PLANNING AND DEVELOPMENT SERVICES STAFF REPORT

For Planning Commission Meeting of August 5, 2015

**SUBJECT: Racquet Club of Ann Arbor Public Sidewalk Waiver
(3010 Hickory Lane)**

RACQUET CLUB OF ANN ARBOR
 SITE PLAN
 SIDEWALK OPTION

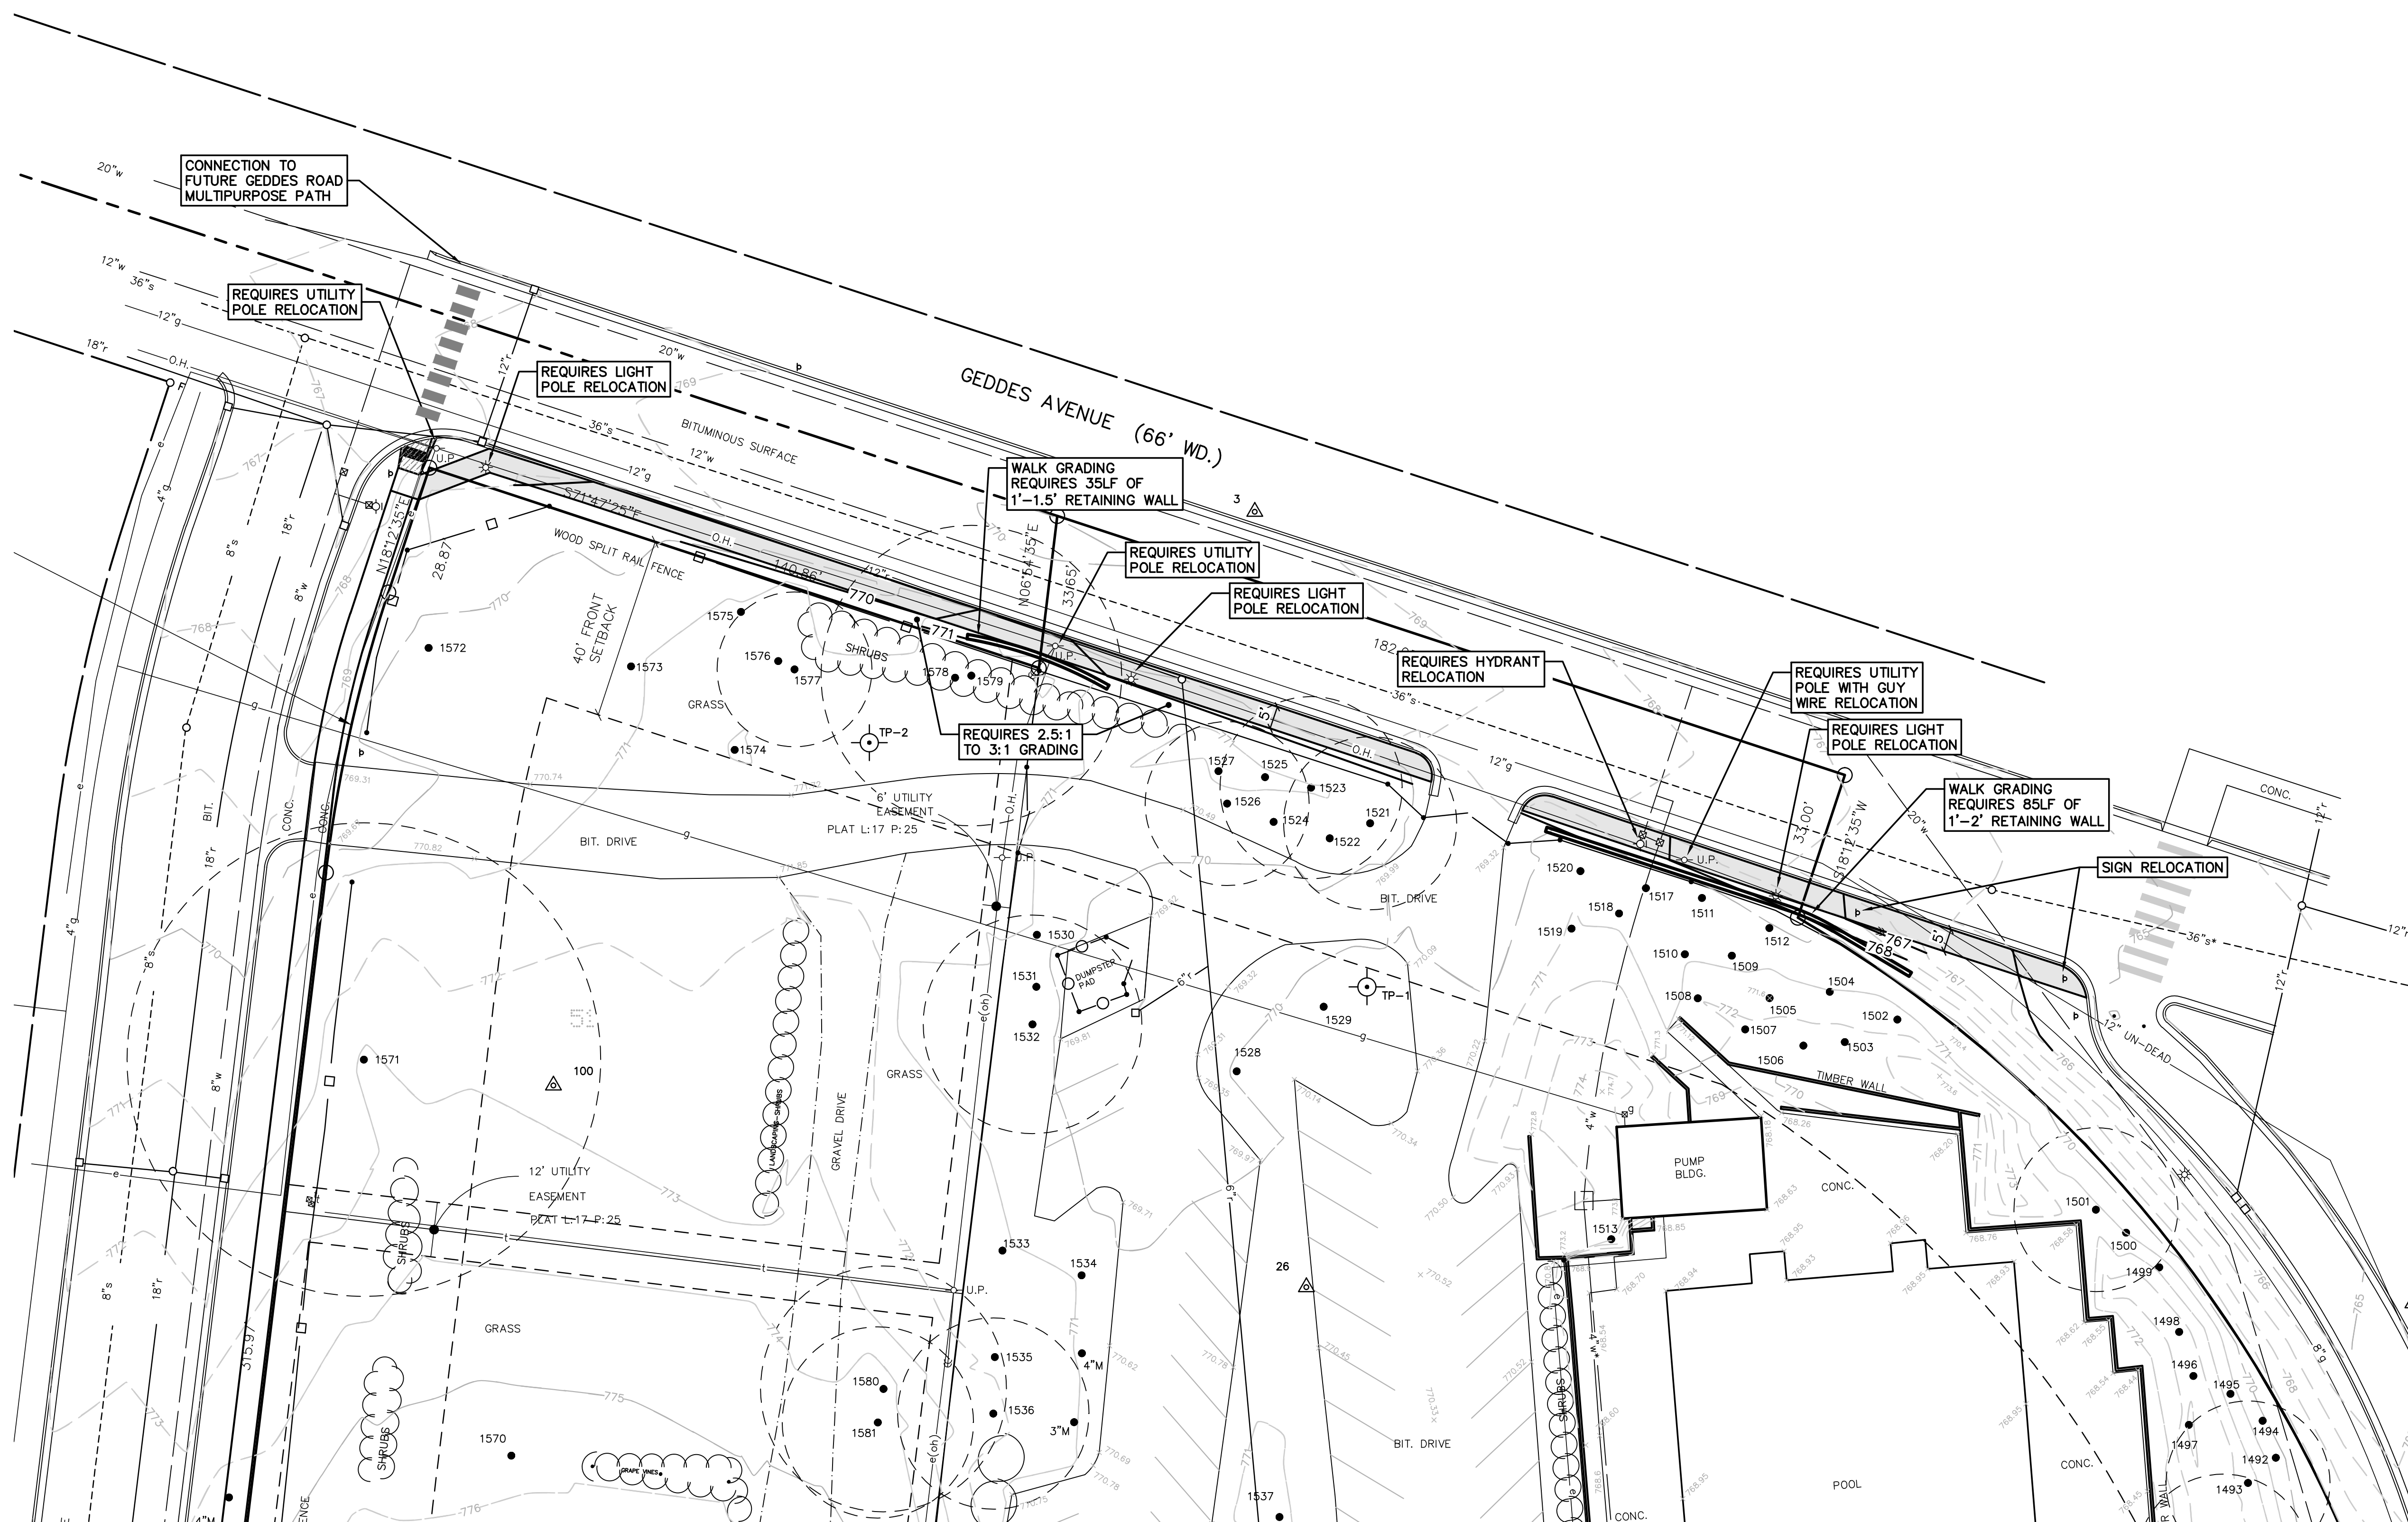
Systems Planning - Staff continues to support construction of a sidewalk along Geddes Avenue and Hickory Lane as The Public Services Standards and Specifications requires sidewalks be provided on both sides of all streets in the City. The petitioner has added sidewalk to a portion of the Hickory Lane frontage, an addition that will improve connectivity to the neighborhood from Geddes, however, by not including sidewalk along the Geddes Avenue frontage, pedestrians will have to cross Geddes Avenue in order to travel east bound, then cross Geddes Avenue again to access Huron Parkway.

The City's roadway consultant on the Geddes Avenue Improvement project, HRC, has looked at the petitioner's Geddes sidewalk concept drawings and associated costs and determined that the projected costs are within the range expected for this alignment. The petitioner's engineer is also exploring whether a narrower sidewalk can be placed within the right-of-way. These findings will be presented, if completed, at the August 5th Planning Commission meeting.

Staff also requested the petitioner show a sidewalk concept on their private property, leaving the existing utilities untouched, as an alternative connection to the Huron Parkway walkway. The petitioner has indicated this alternate path impacts 3-4 landmark trees and 10-14 non-
